Staff Report – August 5th & 19th, 2020

35 HOWARD STREET (LU-20-32) **CERTIFICATE OF APPROVAL PUBLIC HEARING #A**

<u>19 SOUTH STREET (LU-20-27)</u> **CERTIFICATE OF APPROVAL PUBLIC HEARING #1**

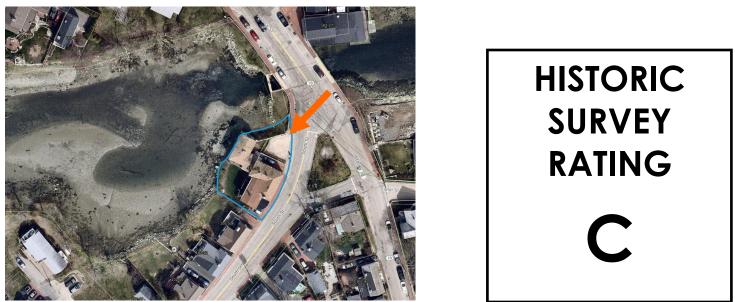
• The proposed window is a Marvin Elevate and it's located on the rear elevation.

458 MARCY STREET (LU-20-137) **CERTIFICATE OF APPROVAL PUBLIC HEARING #2**

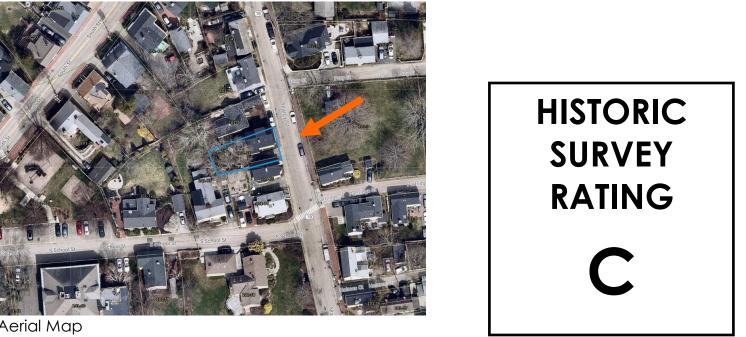
• Replace all the windows in the structure. Note that the Applicant has assessed the windows and determined that they are all replacement windows that are in poor condition. As such, it would be helpful for any commissioners to view the street-facing windows in advance of the

34 HIGHLAND ST. (LU-20-138) **CERTIFICATE OF APPROVAL PUBLIC HEARING #3**

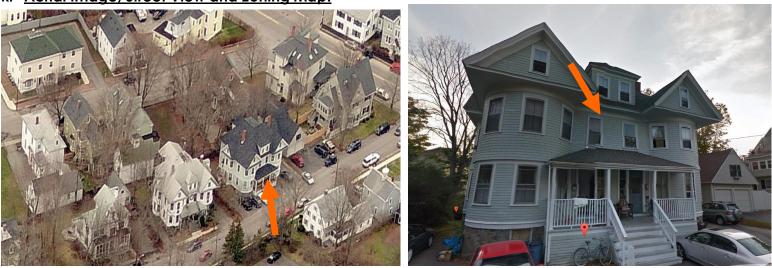
• The applicant is seeking to replace all the existing historic windows in the structure with an

Due to a misunderstanding of the prior feedback from the HDC the applicant's sub-contractor has already replaced many windows on the right side and rear of the structure. The subcontractor proceeded with the window replacement despite not having obtained a building permit for the work. As a response, the city directed the owner to cease work on the project and obtain HDC approval for the existing and remaining replacement windows. Also note that a single window was replaced on the front facade and the owner is seeking to either repair the removed window or replace it with a matching true-divided lite wood window from the righthand side of the house. Based on the recent site visit the applicant is now considering the

- Anderson 100 Series window.
- same approach for the front two basement windows.
